HILLTOPS COUNCIL – DA2021/0133

Request for clarification

Bald Hill Quarry Pty Ltd submits the following information in response to requests received from Hilltops Council and the Southern Regional Planning Panel for clarification on specific items concerning DA2021/0133. The items addressed are those noted as requiring clarification in:

SITE PLAN BUNDARBO QUARRY

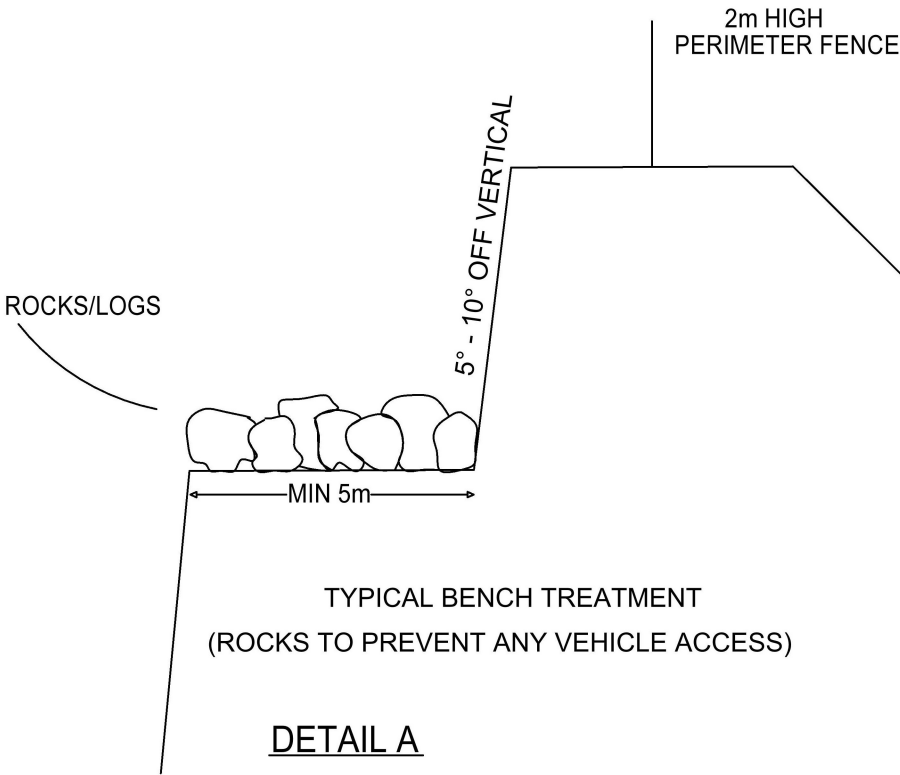
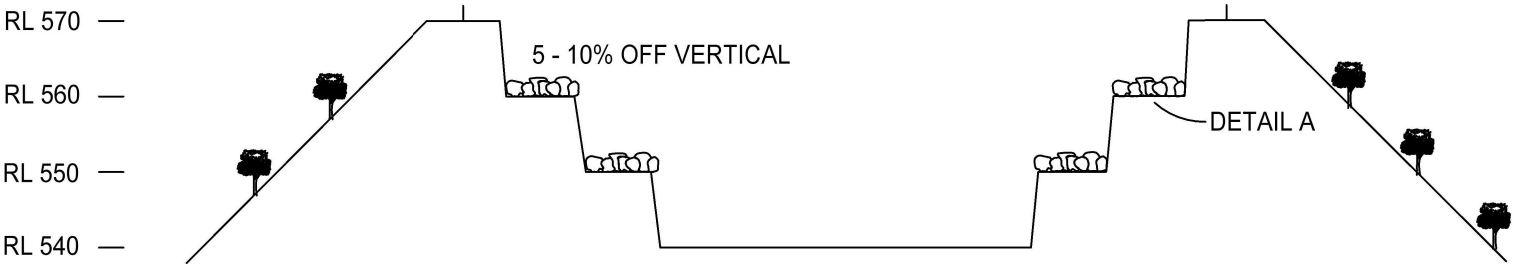
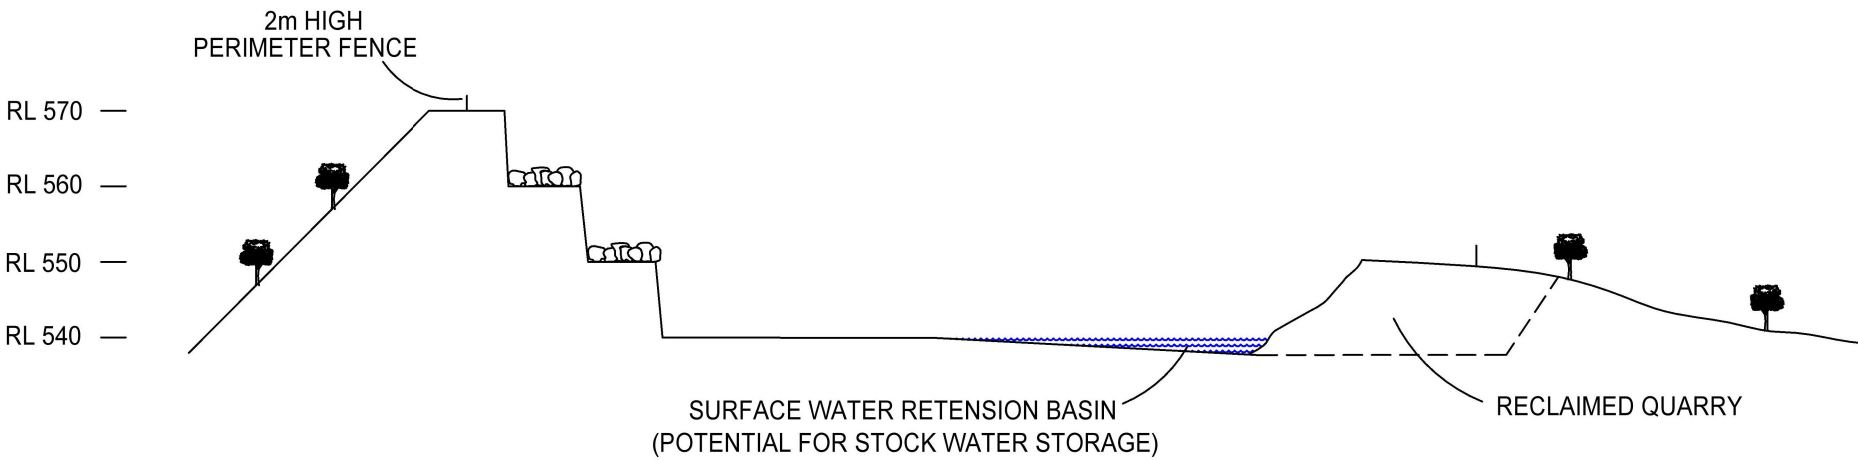
A) Details around the concept closure plan arrangements.

B) Inconsistency in landforms shown in engineering plan and schematic diagram in section 7.4.1

A simple 'concept' closure explanation is provided in section 7 of the EIS. Provided here is a plan showing more details around the proposed concept closure landform for the exhausted quarry. The concept closure landform presented here has as its underlying premise, the following:

- i. All areas backfilled with over burden will be revegetated (pasture seeded and self sown trees) and returned to pasture
- ii. Existing surface water system retained...all runoff collected within the quarry perimeter and directed to the internal reservoir sump. Potential for stock watering and fire fighting use to be explored during the life of the quarry.
- iii. Final bench drilled with 5-10 degree sweep back to eliminate potential overhang.
- iv. Berms retain 5m width with rock and log covering to prevent all vehicle access.
- v. Placement of rocks and logs to limit vehicle access to no closer than 5m to any rock face.
- vi. Minimum 2m high security fence installed around pit void to prevent animal access and unauthorized unintentional personal access.

As described in Section 7, there are alternative possible uses that might be considered for the void, necessitating re consideration of the current proposed concept closure land form and requiring a separate detailed formal submission for approval in the later stages of the quarry extraction operation. Detailed descriptions and working drawings would form the formal rehabilitation and end of life.

This inconsistency is remedied in the plan in A) above.

Picture 1

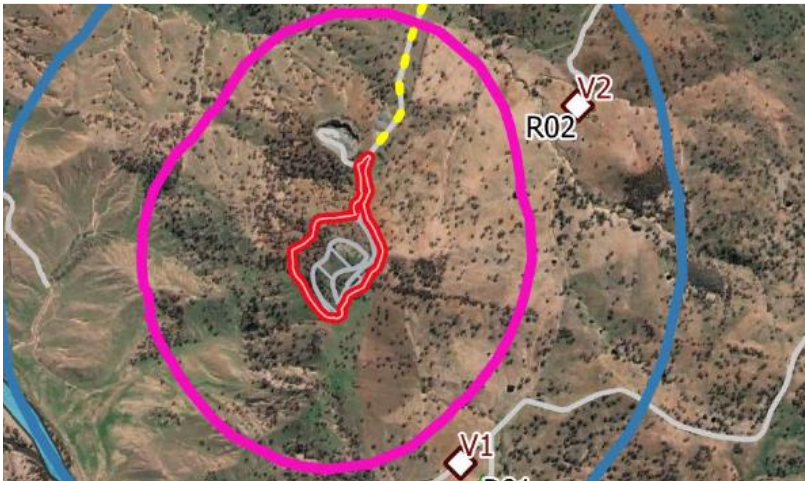
2. View from R2:

Apologies this was not picked up in the review process. The overall view from resident 2 (R2) will appear essentially unchanged. R2 being located to the NE does not have any sight of the entry end to the deposit located at the S end of the hill. Any change in the skyline profile occurs incrementally over the life of the quarry pit possibly 25 years or more. The statement describing a view 'transformed from yellows and greens to a stark white/grey' are patently incorrect. Apart from some machinery (excavator and or drill rig) being visible periodically, some temporary minor earth works may be observable but would comprise less than 1% of the view, and for a short period only (2-3 weeks). The dominant view will remain as the existing vegetated natural landscape.

The bulk of the ongoing construction of the quarry pit will be below the rim of the hill. An example of what this residence will see is shown below (picture 1). Shown is an

equivalent view taken of the Bald Hill Quarry hill which reflects exactly how the Mt Bundarbo quarry will appear.
